10/728,734 filed 12/05/2003

Chien et al.

Reply to Office action of 03/22/2007

**Amendments to the Drawings:**

Figure 4A

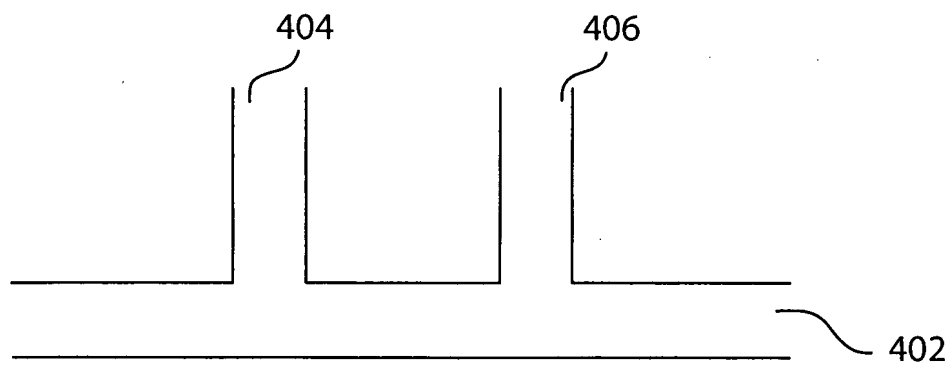
Added  
reference  
numbers  
402, 404, 406

Figure 4B

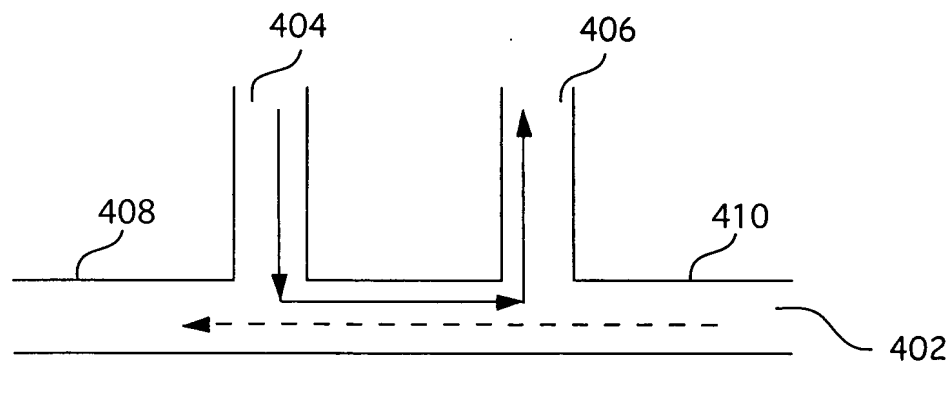
Added  
reference  
numbers  
408, 410

Fig. 6A

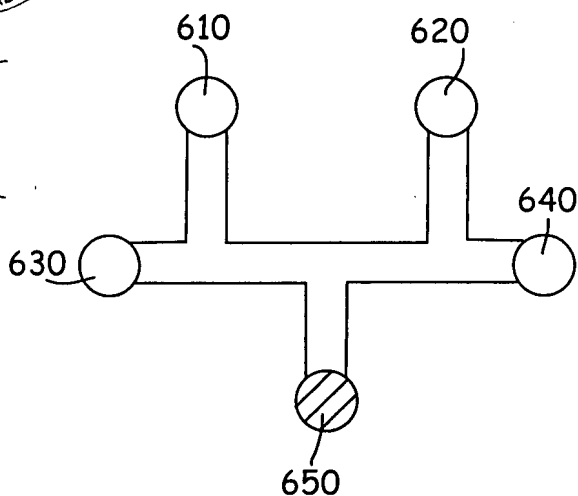
The drawings were objected to as failing to comply with 37 CFR 1.84(p)(5) because the reference characters "600", "692", "694", and "696", seen in one or more of Figures 6A, 6C, and 6D were not mentioned in the description. These characters have been

Removed  
reference  
number  
600

removed from the figures, and a replacement drawing sheet has been provided along with an annotated sheet showing the changes.
